Addendum No. M-02

Reference: Added Scope and clarification

Issue Date: November 6, 2024

Project: UHN TWH – SEM & Corridor (EXP Project Number MRK-23004289-A0)

TITLE:
UNDERGROUND FLOOR PLAN - NEW WORK - MECHANICAL

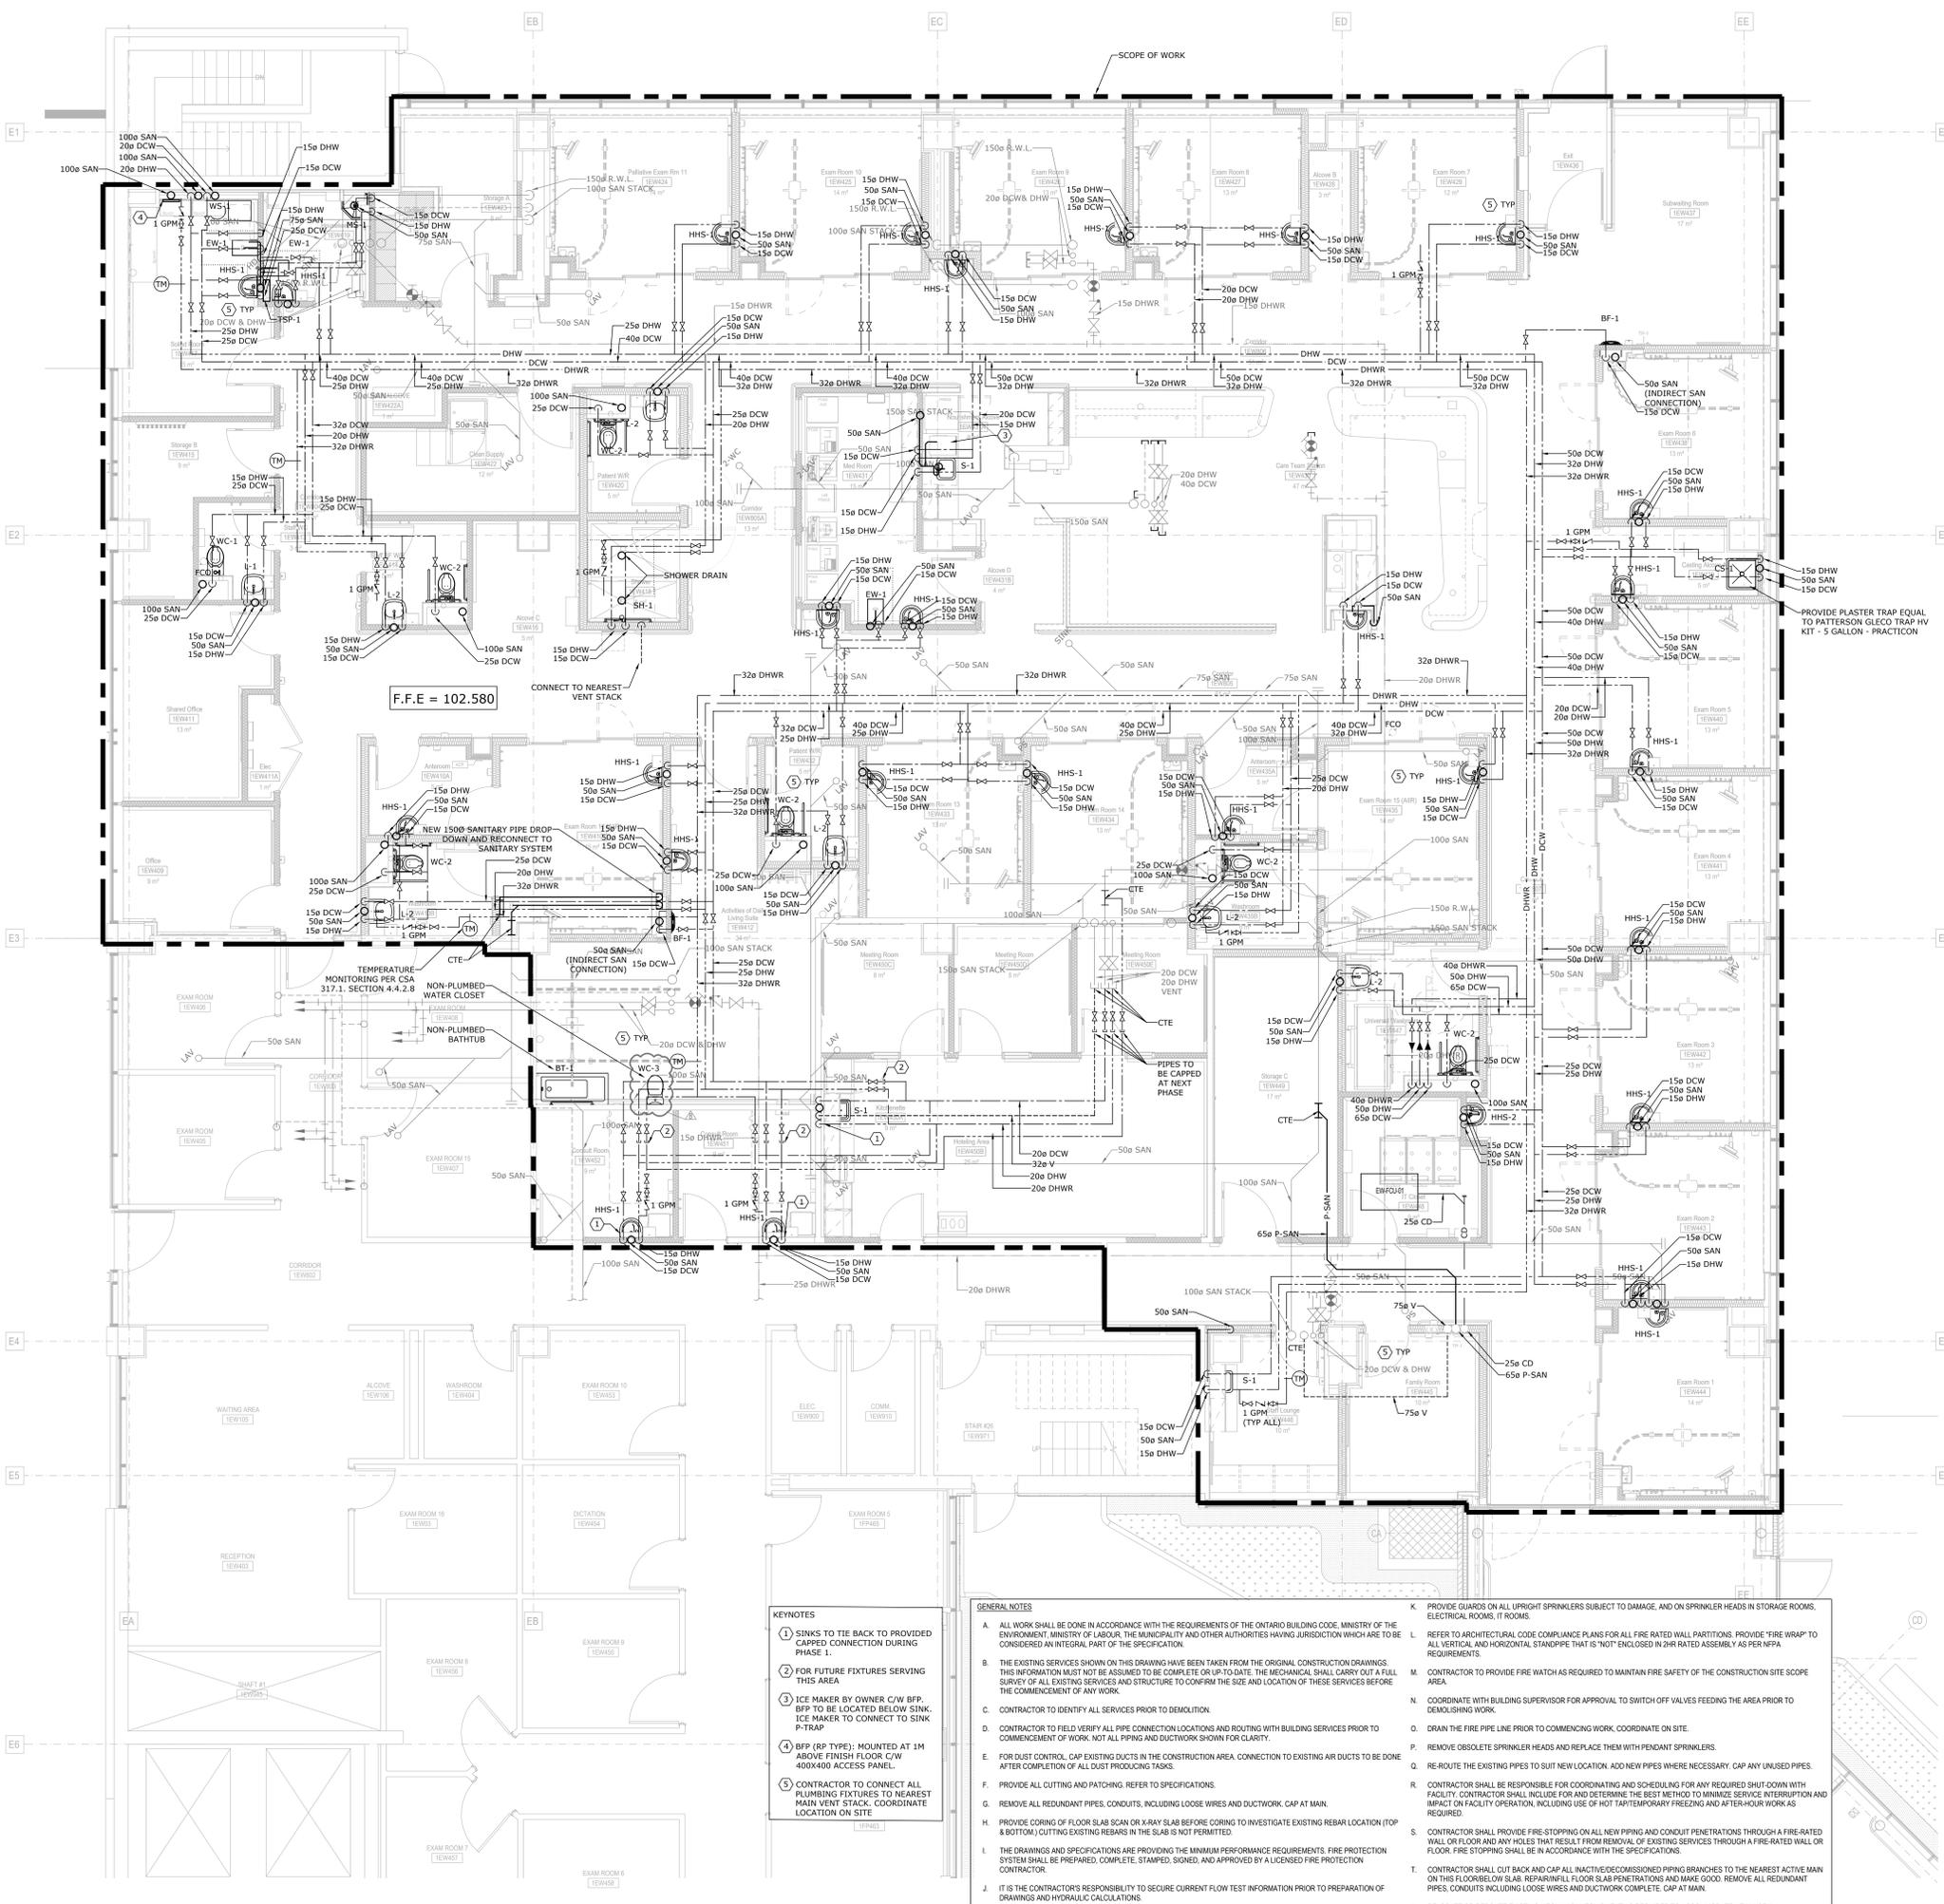
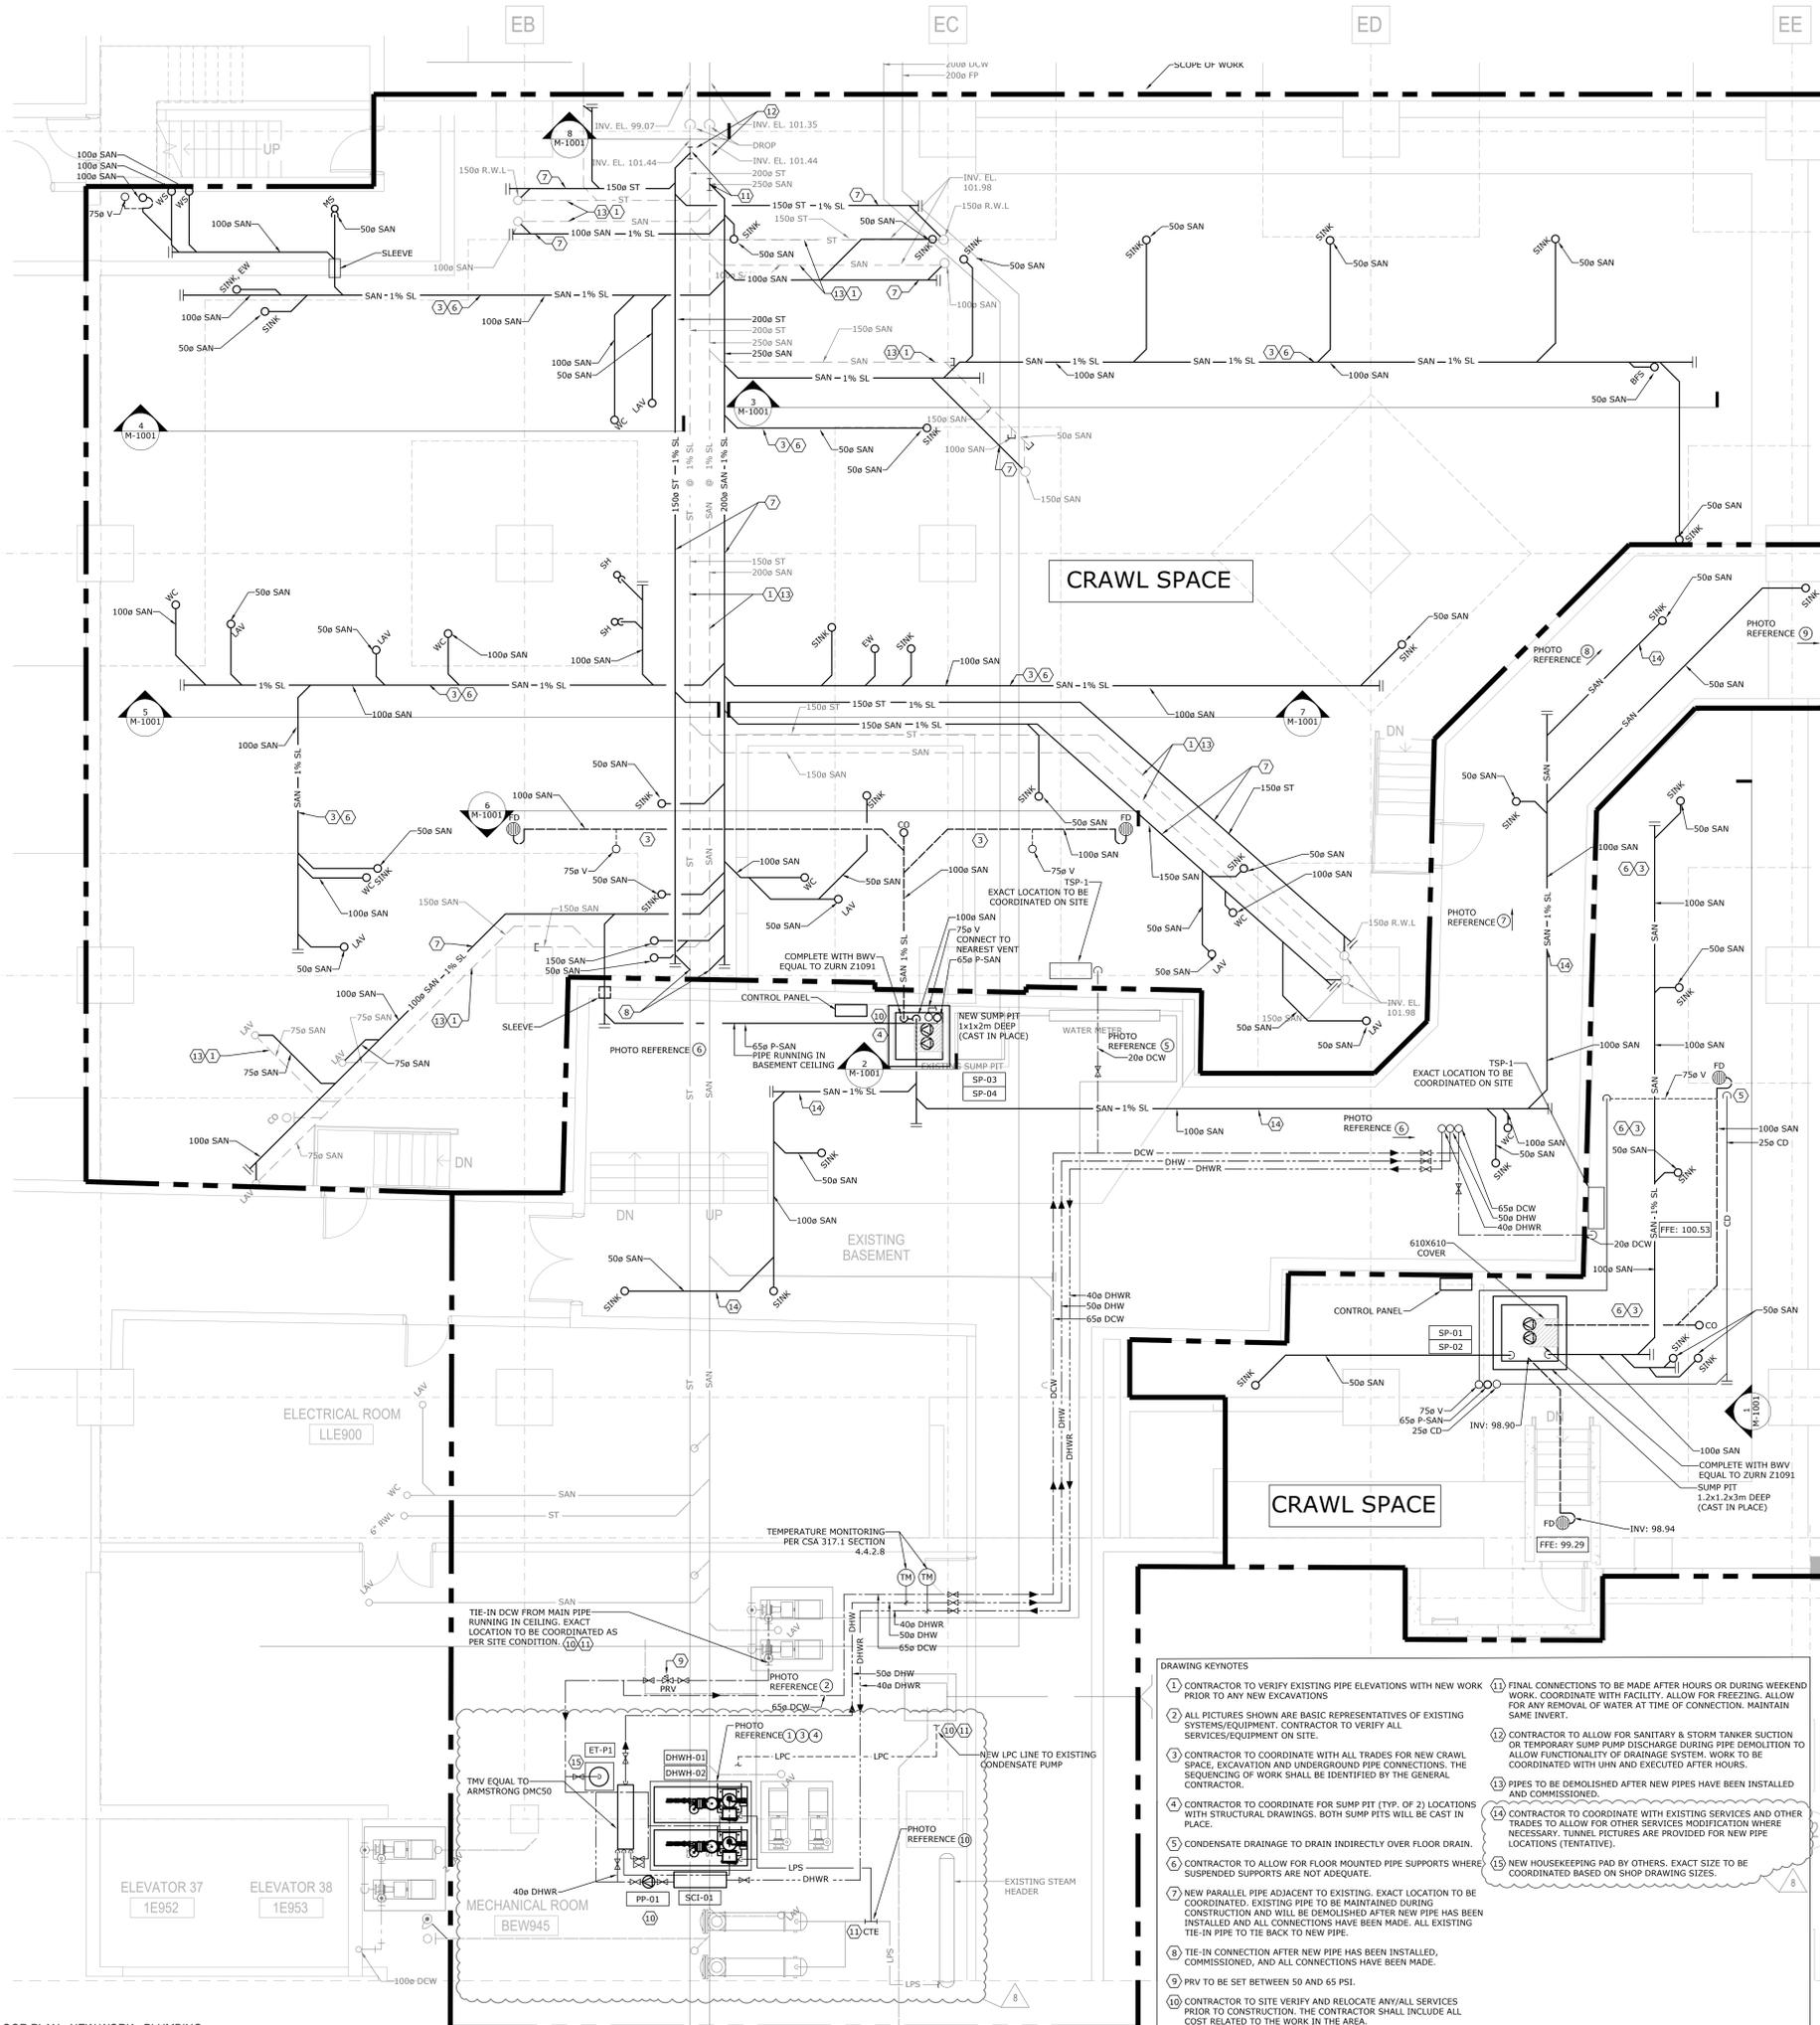
- 1.1.5. **M-111 – UNDERGROUND FLOOR PLAN – NEW WORK – PLUMBING**
- .1 Low pressure steam pipe routing revised.
 - .2 Added picture reference for the steam tie-in point.

- .3 Added picture reference for the water heater location.
 - .4 Added picture reference for the mechanical room.
 - .5 Revised locations of thermostatic mixing valve, expansion tank, PP-01, and silver copper ionization.

- .6 Added note for housekeeping pad, and revised note for tunnel space.
- 1.1.6. **M-112 – LEVEL 1 FLOOR PLAN – NEW WORK – PLUMBING**
- .1 Added non-plumbed toilet 'WC-3'

TITLE:
 LEVEL 1 FLOOR PLAN - DEMO - VENTILATION

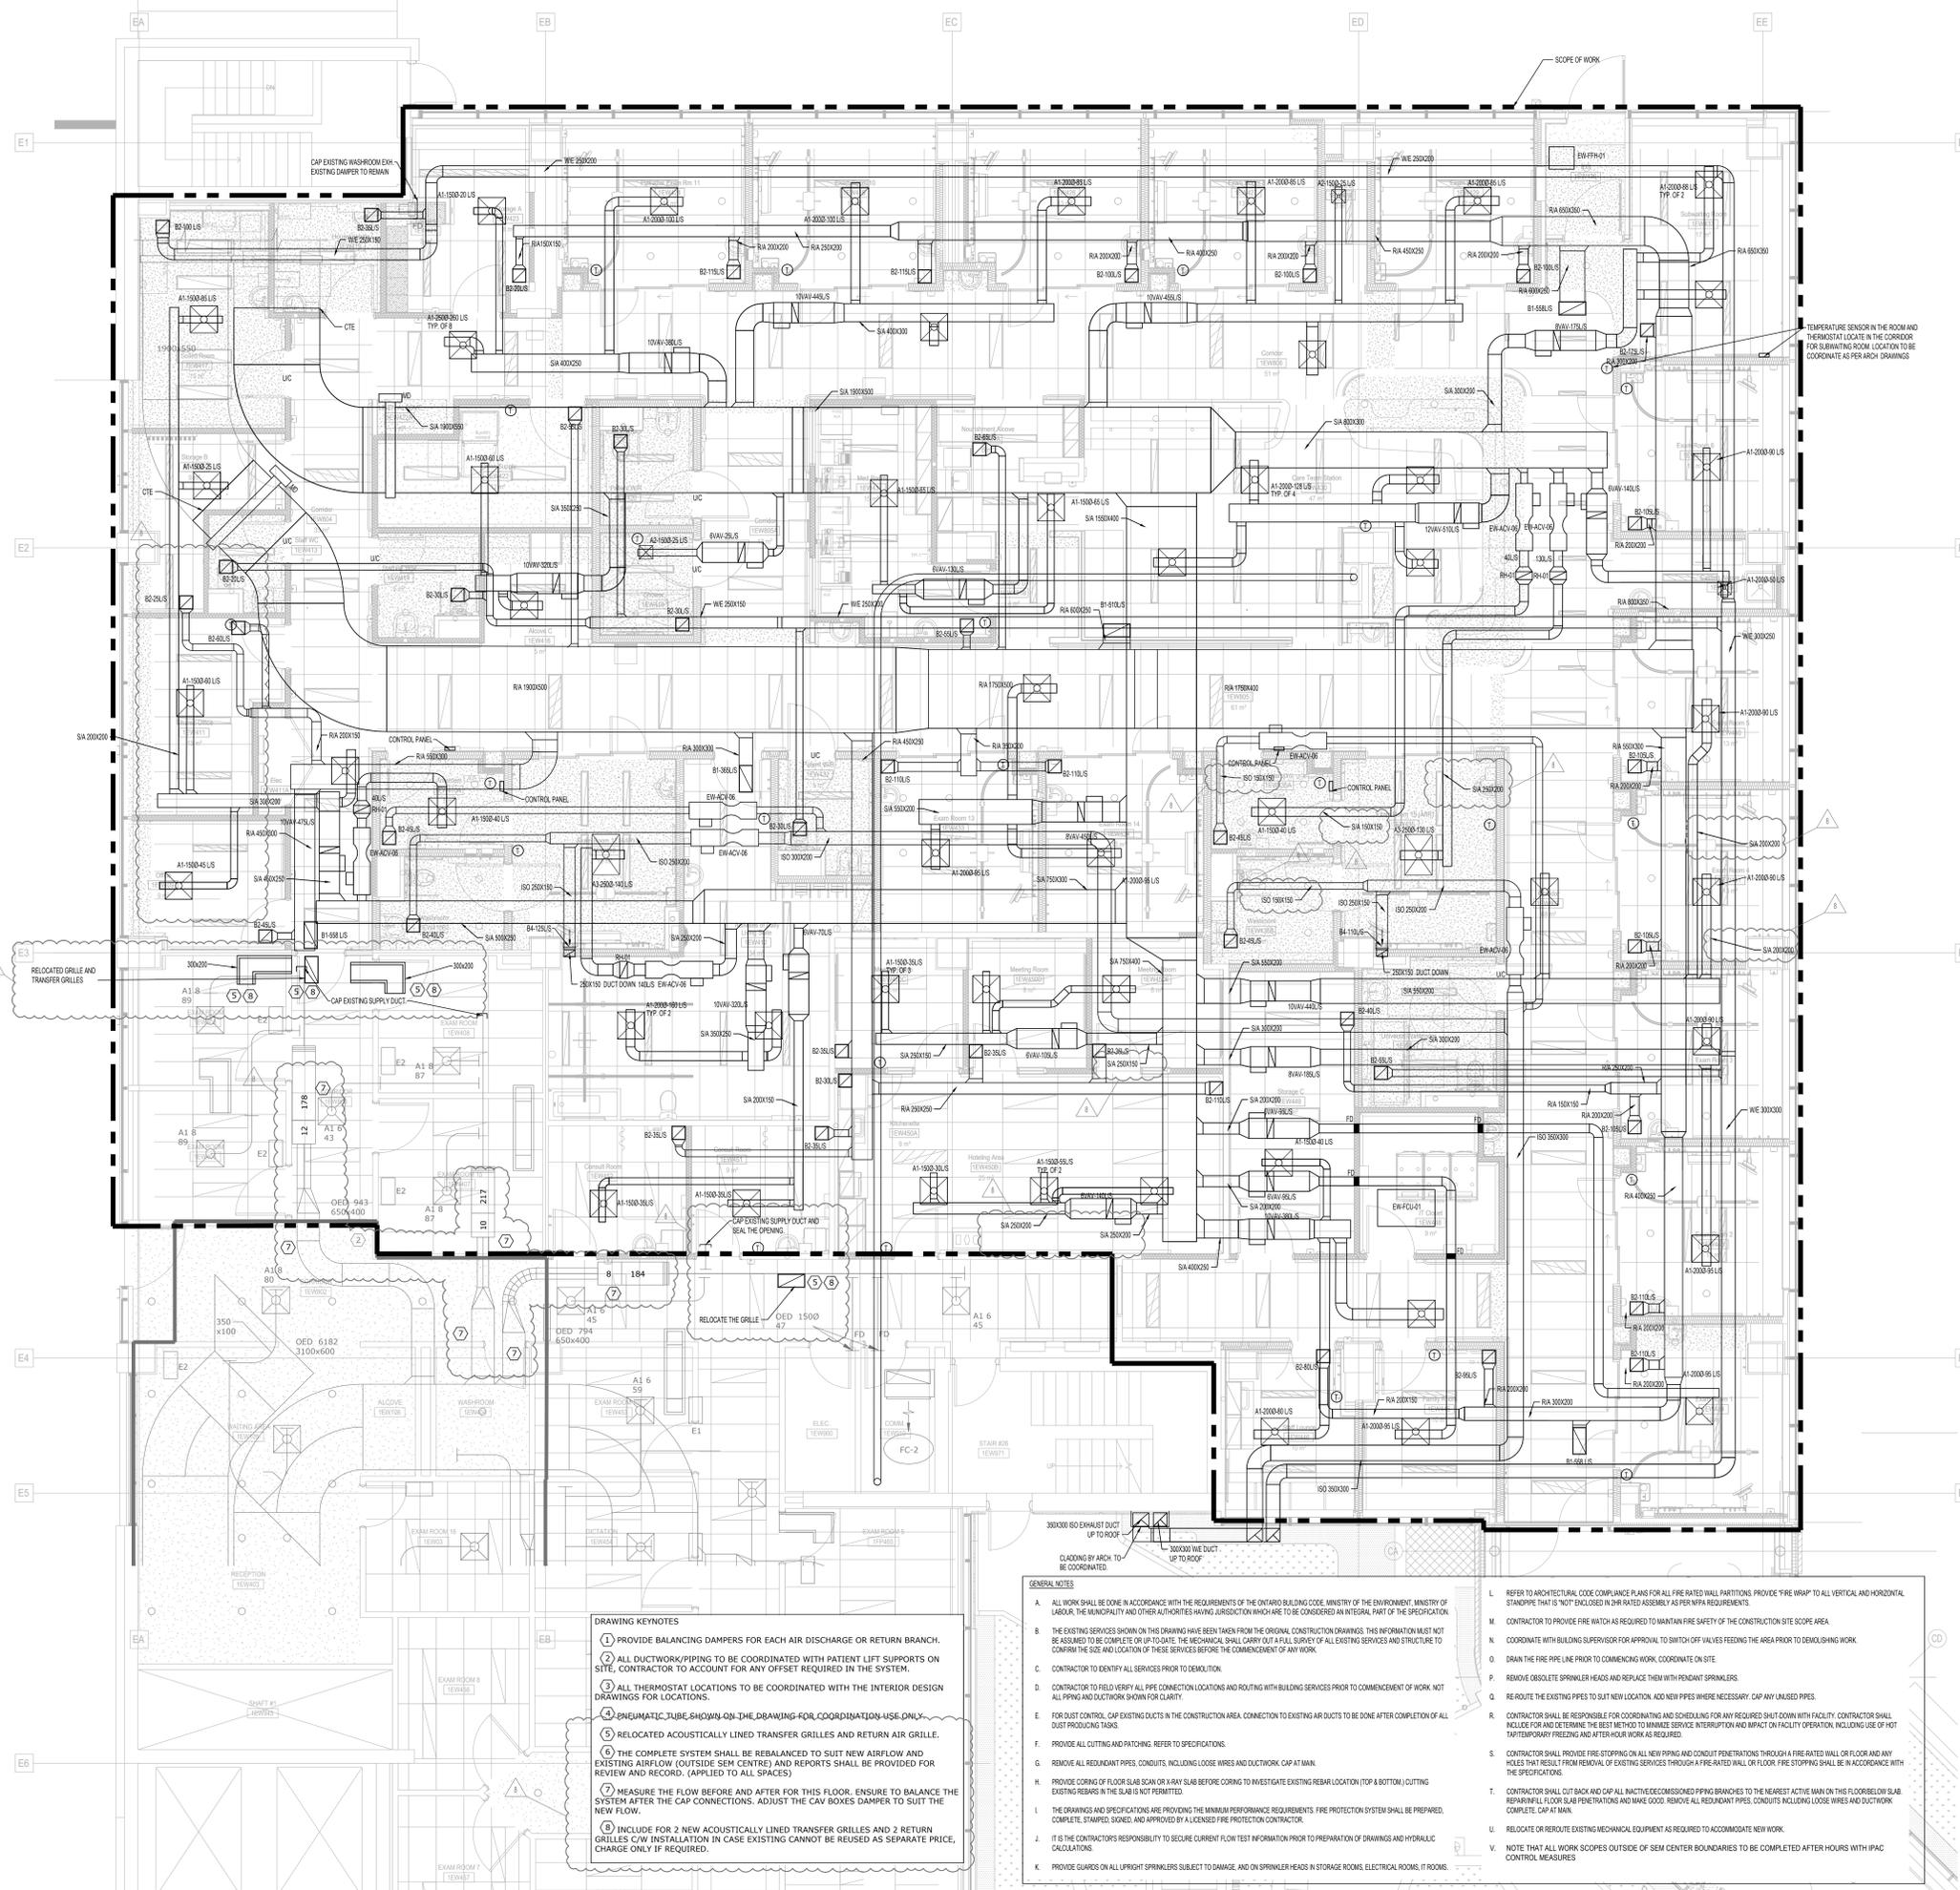
- 1.1.7. **M-201 – LEVEL 1 FLOOR PLAN – DEMO – VENTILATION**
- .1 Relocated transfer grilles and return grilles.
 - .2 Added drawing keynotes.
 - .3 Updated the notes.
